QUEENSLAND COMPETITION AUTHORITY:

AURIZON CENTRAL QUEENSLAND COAL NETWORK

CAPITAL EXPENDITURE REVIEW FY 19

Figure 7.2: Rail head table wear tracking method used by Aurizon (historical, current and projected)

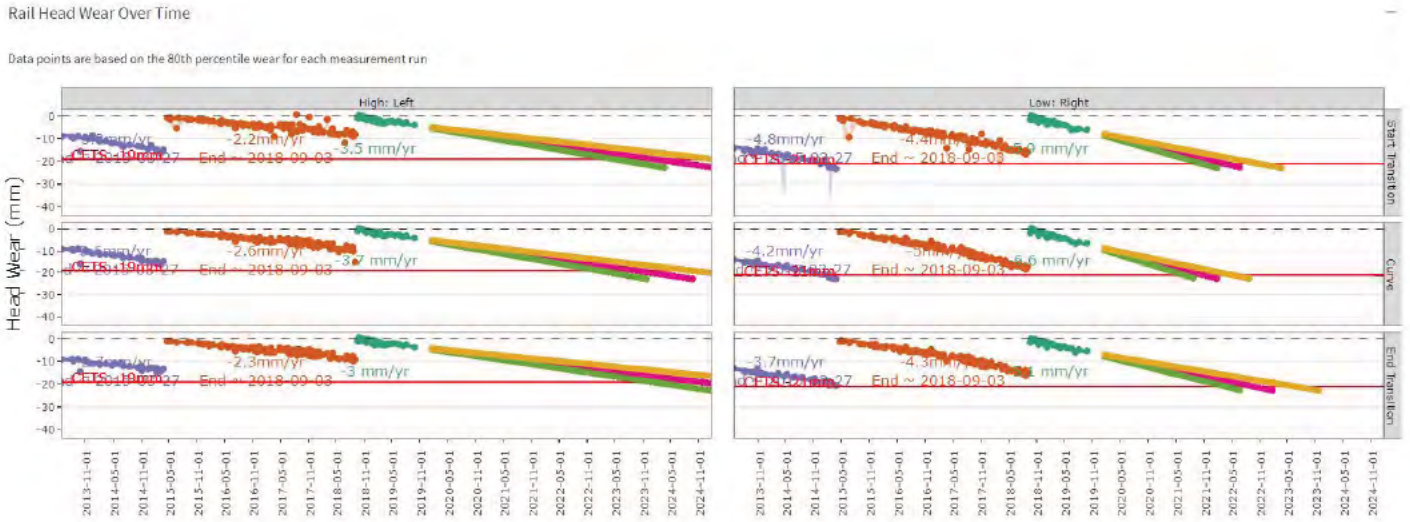
Rail head wear data has been retained by Aurizon and used to predict future head wear. This allows Aurizon to predict the remaining life of the rail; when it reaches the maximum allowable rail head wear permissible under CETS Module 2.

This information is presented graphically by Aurizon allowing the reviewer to clearly see this information and predict wear rate. An example of Aurizon’s table wear tracking is shown below in Figure 7.2 and an example side wear tracking is shown in Figure 7.3.

Figure 7.3: Rail head table wear tracking method used by Aurizon (historical, current and projected)

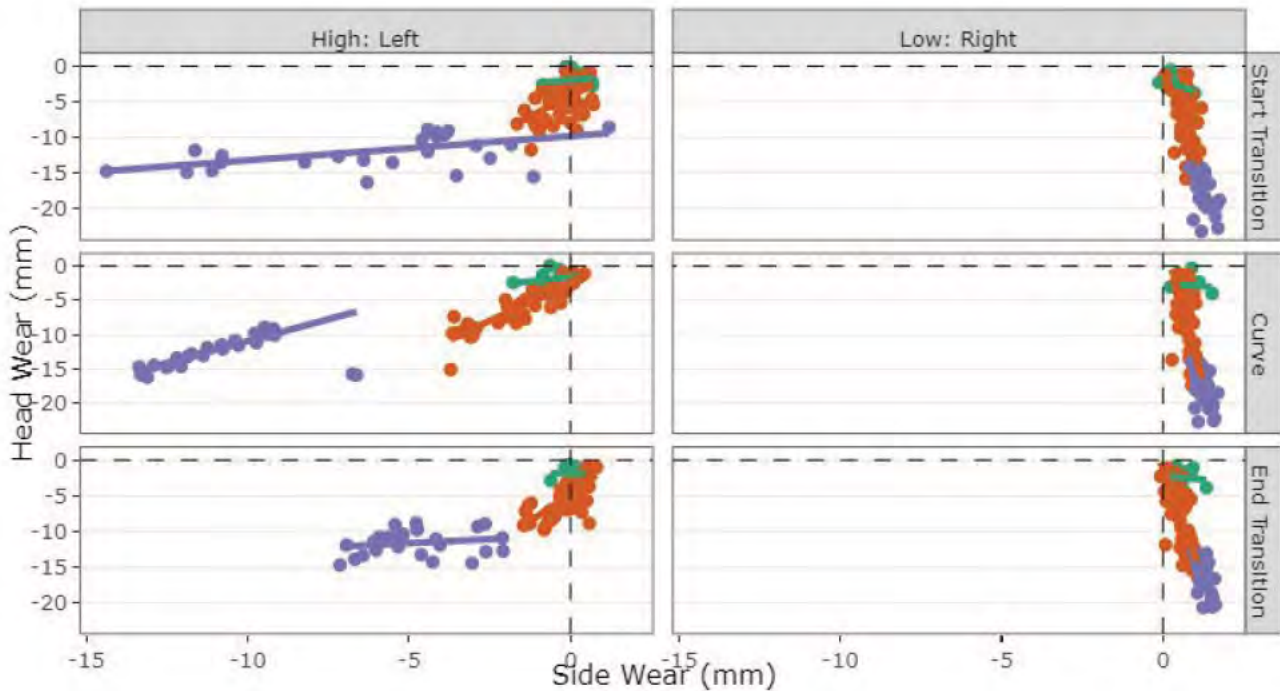
Aurizon’s development of this rail wear monitoring system should be commended. It is effective and:

²⁹ It could be assessed that table wear of 15 mm may be too early to replace the rail. However, rail renewal will close a line to traffic and the renewal project must be planned and coordinated with all stakeholders up to 12 months in advance. Leaving a marginal quality rail in place could cause an unplanned failure which will lead to undesirable operational impacts and higher unit costs. These factors mean it is conservative and prudent to replace the rail earlier rather than later and risk an unplanned failure.

Figure 7.15: Increasing trend in control system faults

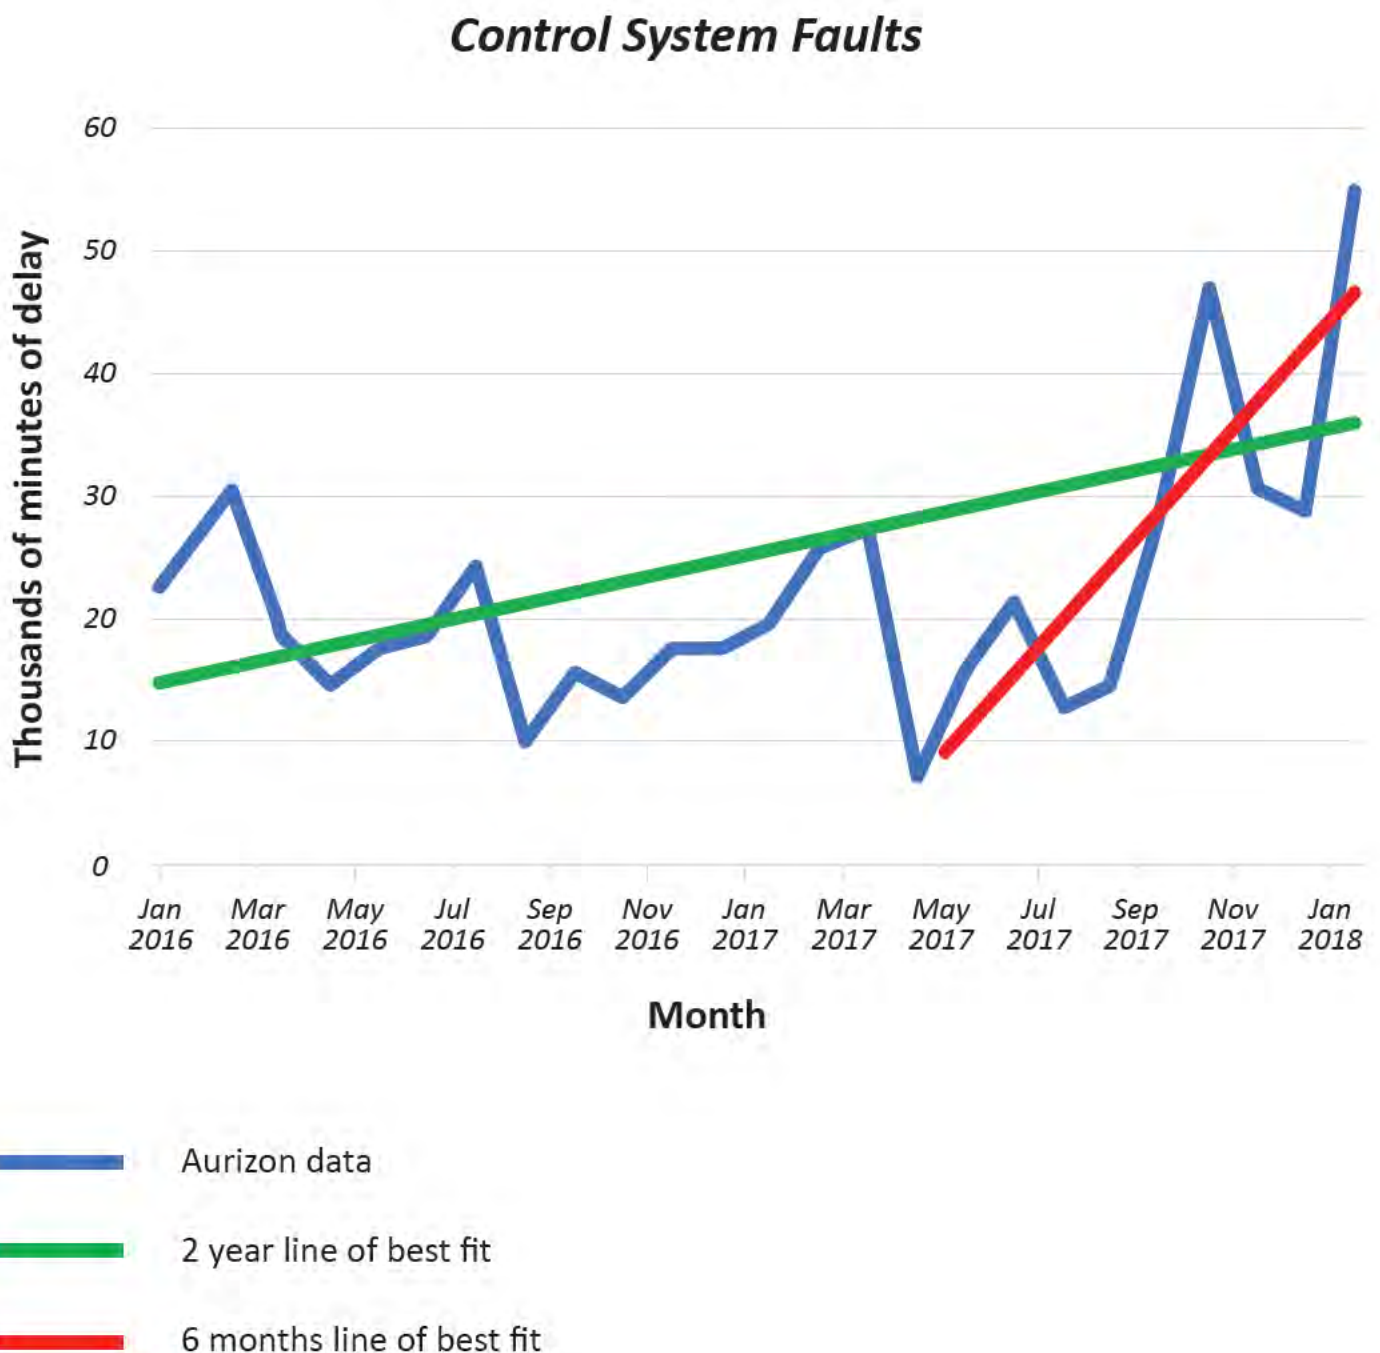
FCG found while researching the data provided by Aurizon that there had been significant and increasing contribution from control system equipment failures to network disruptions, see Figure 2.15 below. Considering this trend FCG expected significant end of life replacements of ageing assets and technology upgrades in a structured program designed to deal with the deteriorating control system reliability.
